Division of Public Utilities

June 27, 2008 email to PacifiCorp

Appendices: Assessment of Long-Term, System-Wide Potential for Demand-Side and Other Supplemental Resources

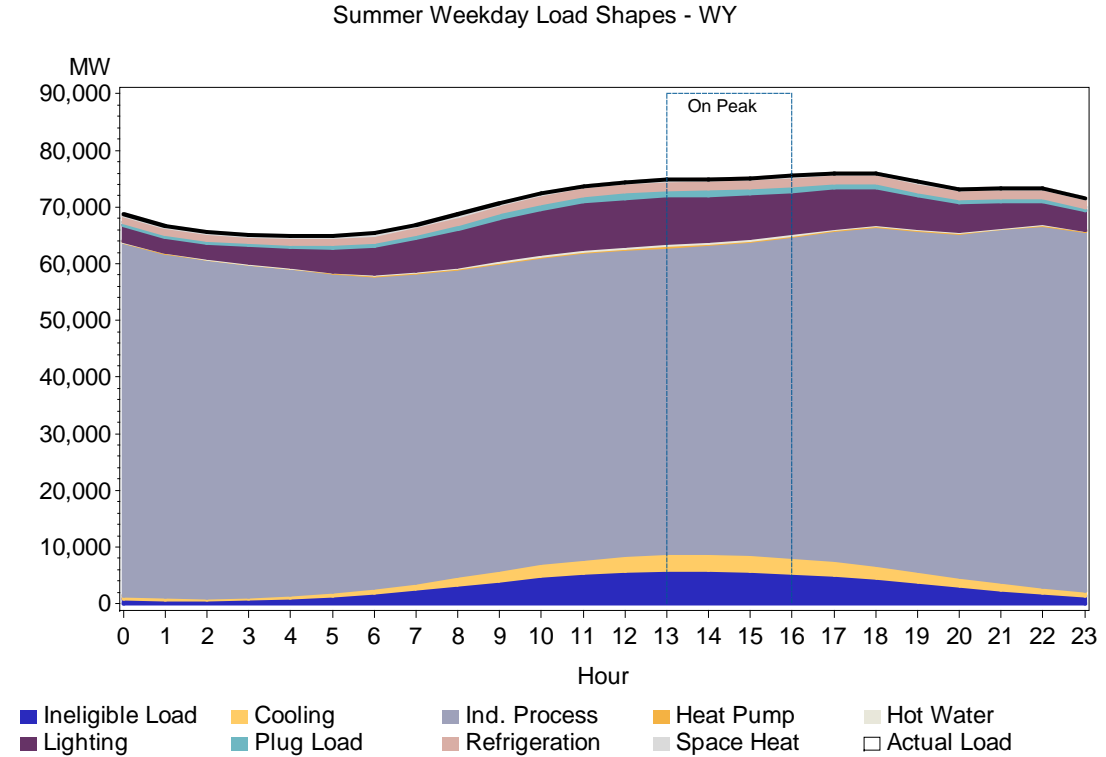
2. Figures B.16 (Wyoming Residential Load Shape) and B.17 (Wyoming C&I Load

Shape) are identical. It appears that B.16 is incorrect. -Quantec

Company Response: Figure B.17 is incorrect and the study has been updated with the correct graph below.
